KANSAS GAS AND ELECTRIC COMPANY

KMLNRC-017
Re: NRC Docket No. STN 50-482
Subj: 50.55(e) Report Bergen
Patterson Strut Assembly

INTERFERENCE PROBLEM BETWEEN
PIPE CLAMPS AND MECHANICAL
SHOCK ARRESTORS

WOLF CREEK GENERATING STATION, UNIT NO 1

FIGURE 1

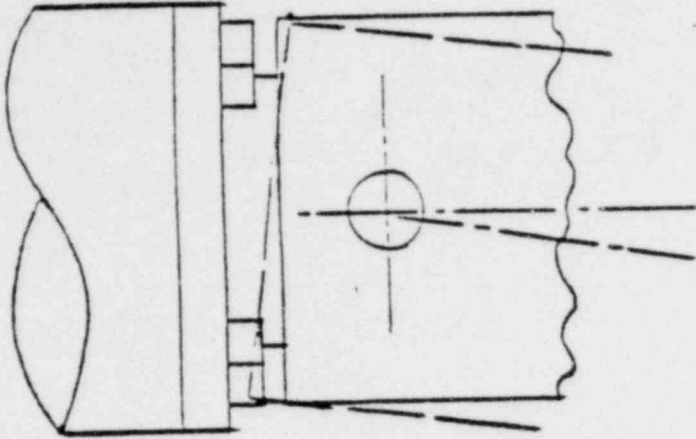
6° off-axis rotation of clamp creates interference between bolt head and clamp.
